JEFFREY L. KLEINMAN
ATTORNEY AT LAW
THE AMBASSADOR
1207 S.W. SIXTH AVENUE
PORTLAND, OREGON 97204
TELEPHONE (503) 248-0808
FAX (503) 228-4529
EMAIL KleinmanJL@aol.com

Re: LU 16-278621 DZM GW, PC #16-262122 (Fremont Apartments)

I. COMMISSIONER FISH’S QUESTION

Figure 1A

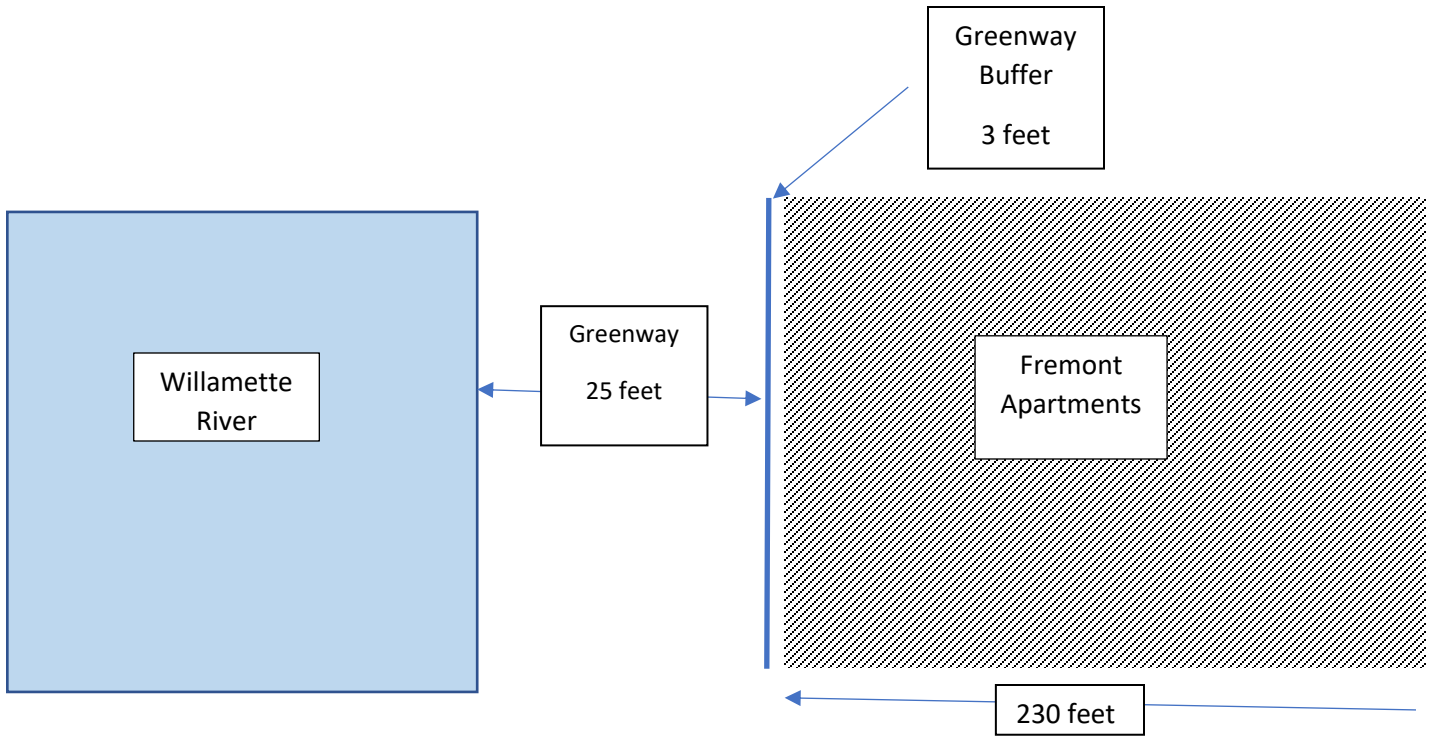
At the appeal hearing there was some uncertainty expressed on the nature of the requested modification to the building length and its effect on the Willamette River greenway. To clarify this issue, we created Figure 1 to show the effects of the Fremont Apartments on the greenway. Figure 1A shows the greenway configuration as proposed by Fremont Apartments. Moving from left to right one has the Willamette River, then a 25-foot greenway. Adjacent to the greenway is the Fremont Apartments with a 3-foot greenway buffer. With this configuration the greenway path necks down to 12 feet 9 inches due to the limited space available in the greenway and greenway buffer.

Figure 1B

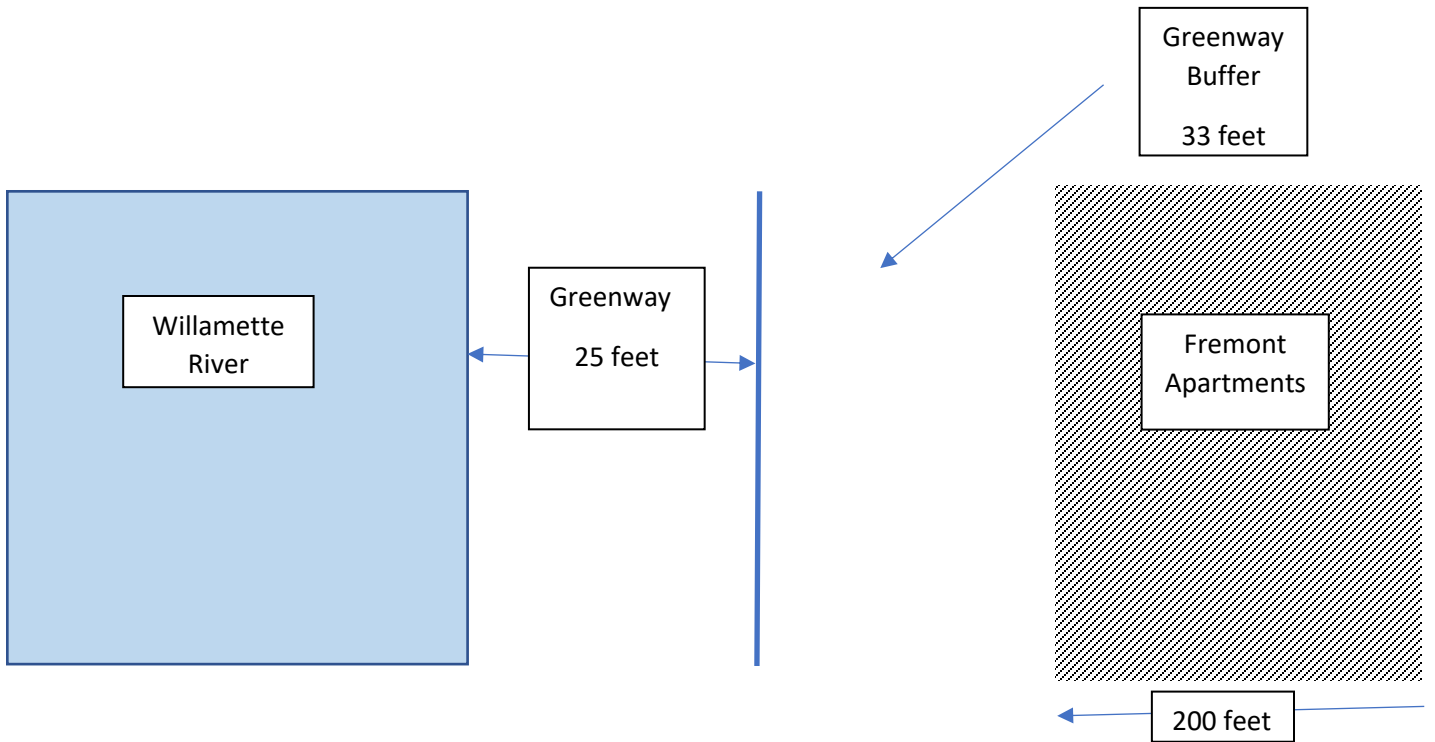
Figure 1B shows the greenway configuration that is mandated by the current Central City plan. From the left you have the Willamette River, then a 25-foot greenway with a 33 feet greenway buffer. The increase in greenway buffer is a result of limiting the building foundation length towards the river to 200 feet as required by the current Central City Plan. With the increased width in the greenway buffer and with limited building encroachment one can now easily construct an 18-foot-wide greenway path that is consistent with the greenway path both north and south of the proposed project with ample space to provide additional landscaping and other amenities available for public use and enjoyment. It is also worthy to note the 2035 Central City Plan would require a 50-foot greenway which would double the current 25-foot greenway width and reduce the greenway buffer to 8 feet. This would cause no impact to the combined greenway and greenway buffer areas since in the 2035 plan the maximum building length would still limit the Fremont Apartments building length to 200 feet which is the limiting factor in creating the greenway and the greenway buffer area.
